Access Compliance Report

Public Rights-of-Way

(Curb Ramps)

Intersection ID: 15360	Main Street: NEW_BERN_ST	Cross Street: RAIL_CROSSING_LN	Location: SE
ADA ID: CE727C2F1CCE	Ramp Type: Perp	Initial Pass/Fail: Fail	Overall Compliance: No
Severity Score: 12.5			
Codes/Mitigation Info/Possible Solution		Field Measurements/Component Compliance

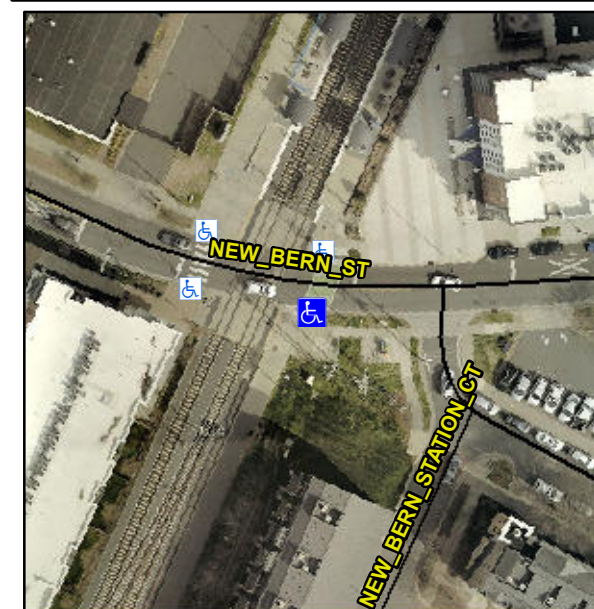
Not Found, R304.2.2

Compliance	Description	Data	Compliance	Description	Data
N/A	Ramp Length (in)	80.0	No	Ramp Slope (%)	9.1
Yes	Ramp Width (in)	136.0	Yes	Ramp XSlope (%)	0.4
N/A	Flare Type LT	N/A	N/A	Flare Type RT	N/A
N/A	Flare Slope LT (%)	N/A	N/A	Flare Slope RT (%)	N/A
N/A	Flare Traversable LT?	N/A	N/A	Flare Traversable RT?	N/A
N/A	Landing Length (in)	N/A	N/A	DWS Provided?	N/A
N/A	Landing Width (in)	N/A	N/A	DWS Contrast?	N/A
N/A	Landing Slope (%)	N/A	N/A	DWS Length (in)	N/A
N/A	Landing X Slope (%)	N/A	N/A	DWS Full Width?	N/A
N/A	Landing Curb? (Y/N)	N/A	N/A	DWS Offset (in)	N/A
N/A	Shared Landing?	N/A			
N/A	Gutter Ponding?	N/A	N/A	Gutter Slope (%)	N/A
N/A	Gutter Lip Ht (in)	N/A	N/A	Gutter X Slope (%)	N/A
N/A	Painted X Walk1?	Yes	N/A	Painted X Walk2?	N/A
	X Walk 1 Direction	To N		X Walk 2 Direction	N/A
N/A	X Walk 1 Width (in)	152.0	N/A	X Walk 2 Width (in)	N/A
	X Walk 1 Slope (%)	3.4		X Walk 2 Slope (%)	N/A
	X Walk 1 X Slope (%)	1.3		X Walk 2 X Slope (%)	N/A

Remove & Replace Entire Ramp.
